ADDENDUM #2

NORTH PLATTE COMMUNITY COLLEGE SOUTH CAMPUS CAFETERIA ADDITION NORTH PLATTE, NEBRASKA 1001

Date Issued: March 20, 2013

**ADDENDUM #2 - #1
C5.0**

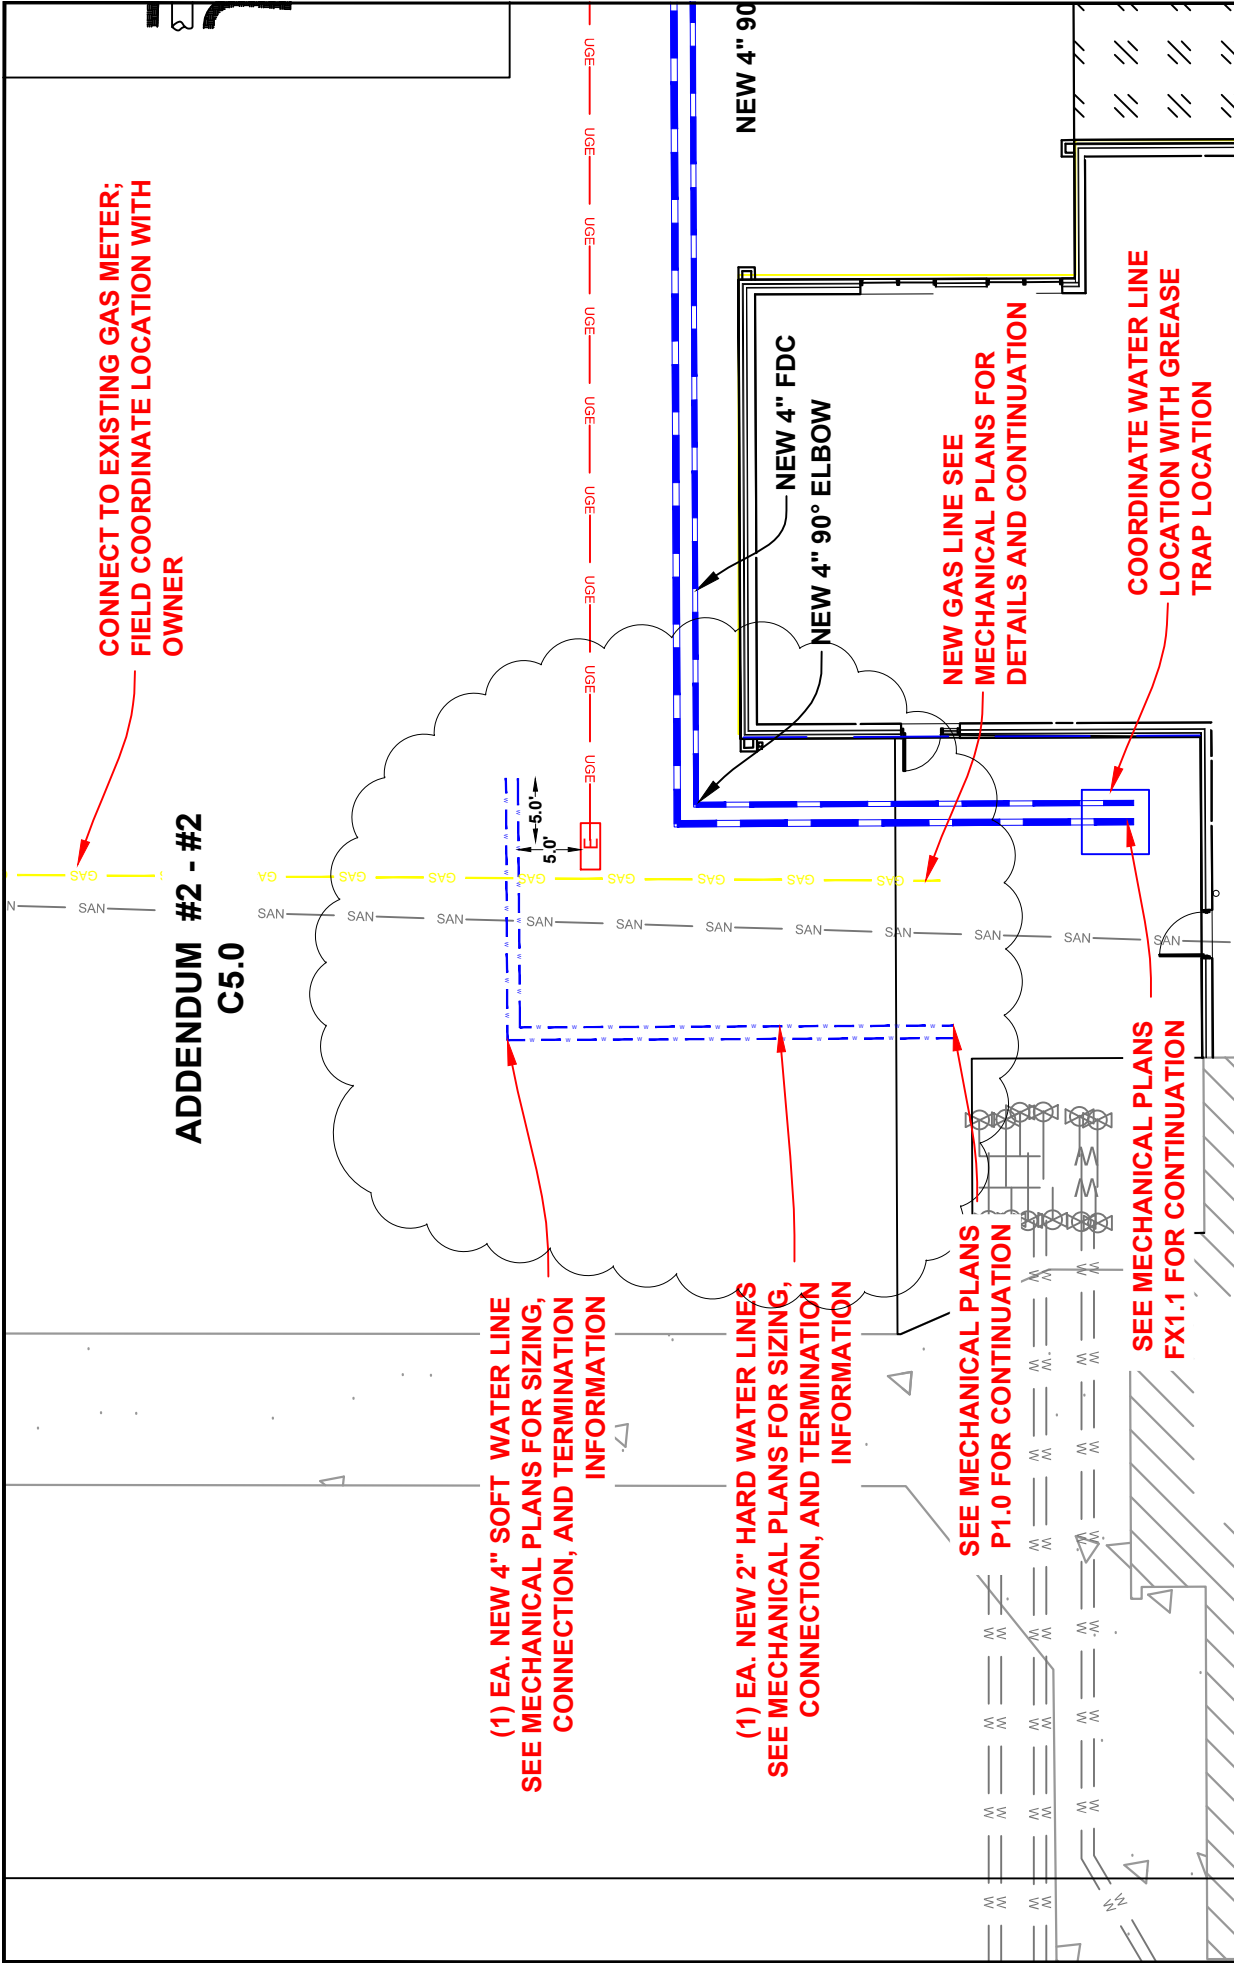
- Addendum #2 - #14 SHEET C5.0 – UTILITY PLAN**
See detail AD2-1. 6” fire line and 4” FDC line are shown as separate lines. 4” 90 deg. elbow added at freestanding FDC inlet. Common concrete pad shown for PIV and freestanding FDC inlet.

**ADDENDUM #2 - #2
C5.0**

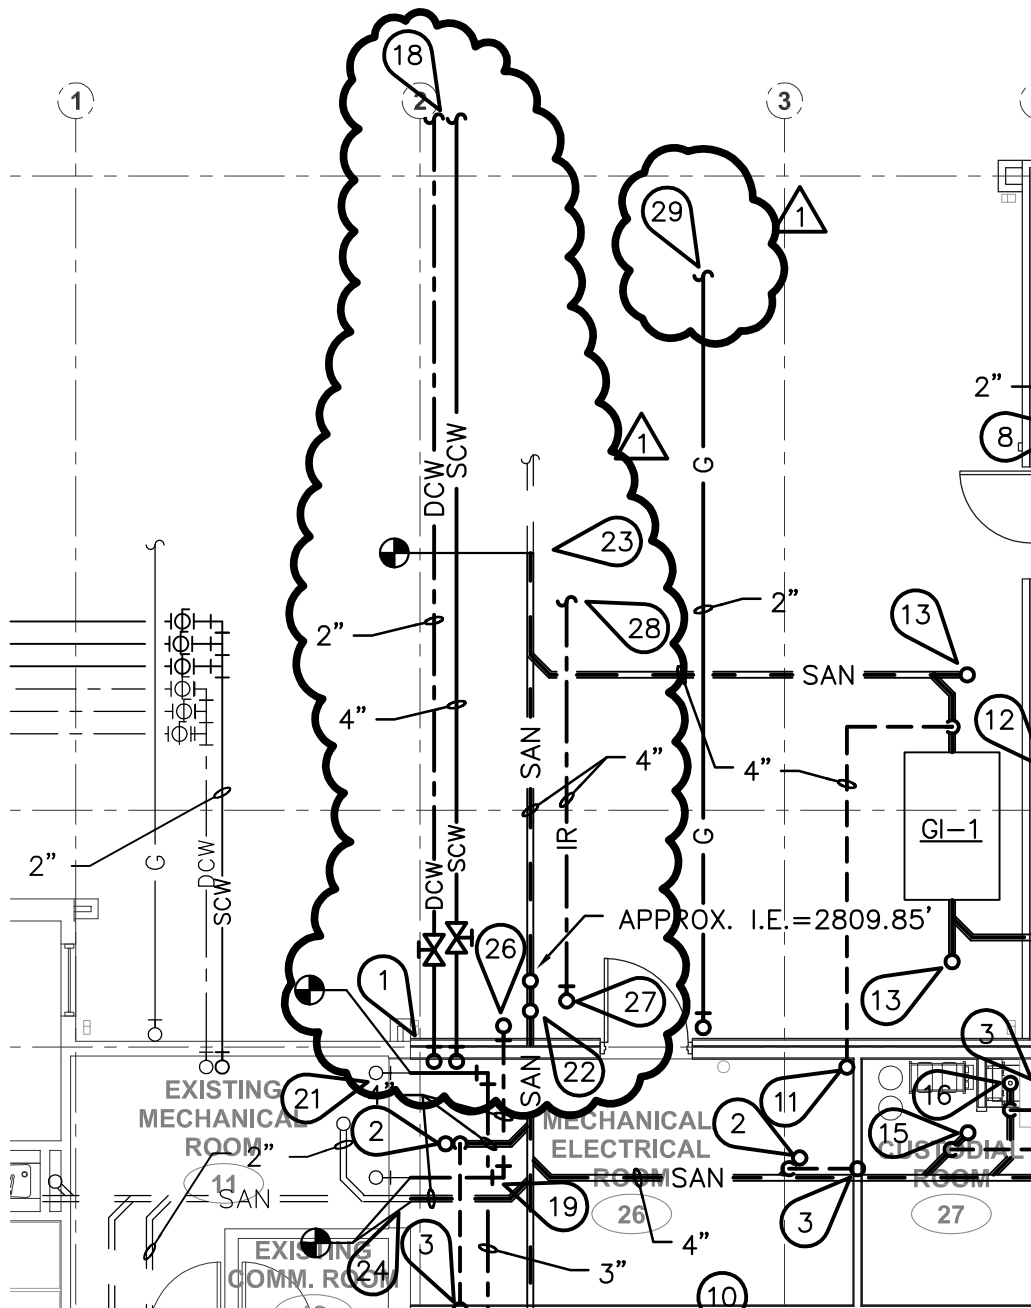
- Addendum #2 - #15 SHEET C5.0 – UTILITY PLAN**
See detail AD2-2. 4” soft water and 2” hard water lines are shown for future addition. Gas line shown.

**(1) EA. NEW 4" SOFT WATER LINE
SEE MECHANICAL PLANS FOR SIZING,
CONNECTION, AND TERMINATION
INFORMATION**

**(1) EA. NEW 2" HARD WATER LINES
SEE MECHANICAL PLANS FOR SIZING,
CONNECTION, AND TERMINATION
INFORMATION**

**NEW GAS LINE SEE
MECHANICAL PLANS FOR
DETAILS AND CONTINUATION**

PLUMBING PLAN - FOUNDATION
 SCALE: 1/8" = 1'-0"

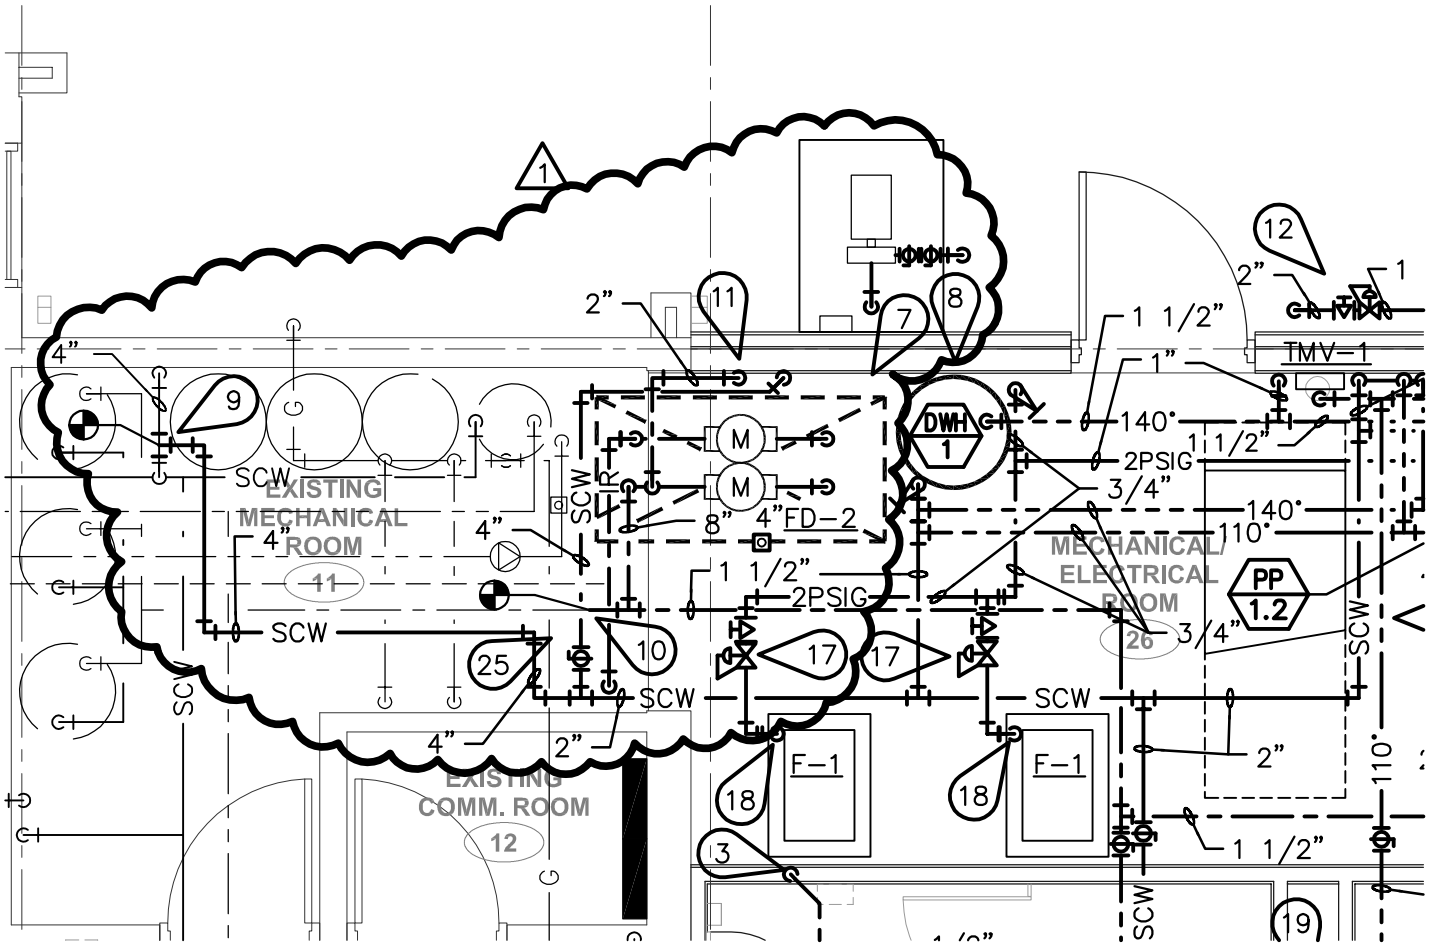
- Addendum #2 - #20 SHEET P1.0 – PLUMBING PLAN – FOUNDATION**
 See attached supplemental drawing P-SK-1 for revised DCW and SCW piping layout.
- Addendum #2 - #21 SHEET P4.1 – PARTIAL PLUMBING PLAN – FIRST FLOOR**
 See attached supplemental drawing P-SK-2 for revised DCW and SCW piping layout.

- ① 4" SCW LINES FROM WATER SOFTENING EQUIPMENT AND AND 2" DCW FROM WATER MAIN ABOVE. SEE P4.1 FOR CONTINUATION.
- ⑱ 4" SOFT COLD WATER AND 2" DCW LINES VALVED AND CAPPED FOR FUTURE DORMITORIES. EXTEND WATER LINES PAST THE LIMITS OF CONSTRUCTION. SEE CIVIL PLANS FOR CONTINUATION.
- ⑲ NEW 2" GAS LINE FROM EXISTING METER. SEE CIVIL PLANS FOR CONTINUATION.

TAP EXISTING 4" SOFT COLD WATER (SCW) WITH NEW 4" SCW LINE AND ROUTE TO PLUMBING EQUIPMENT IN MECHANICAL/ELECTRICAL ROOM 26.
- 
 4" SCW AND 2" DCW LINES DOWN TIGHT TO WALL TO BELOW FLOOR. SEE P1.0 FOR CONTINUATION. OFFSET PIPING AROUND FOUNDATION WALL AND FOOTING.
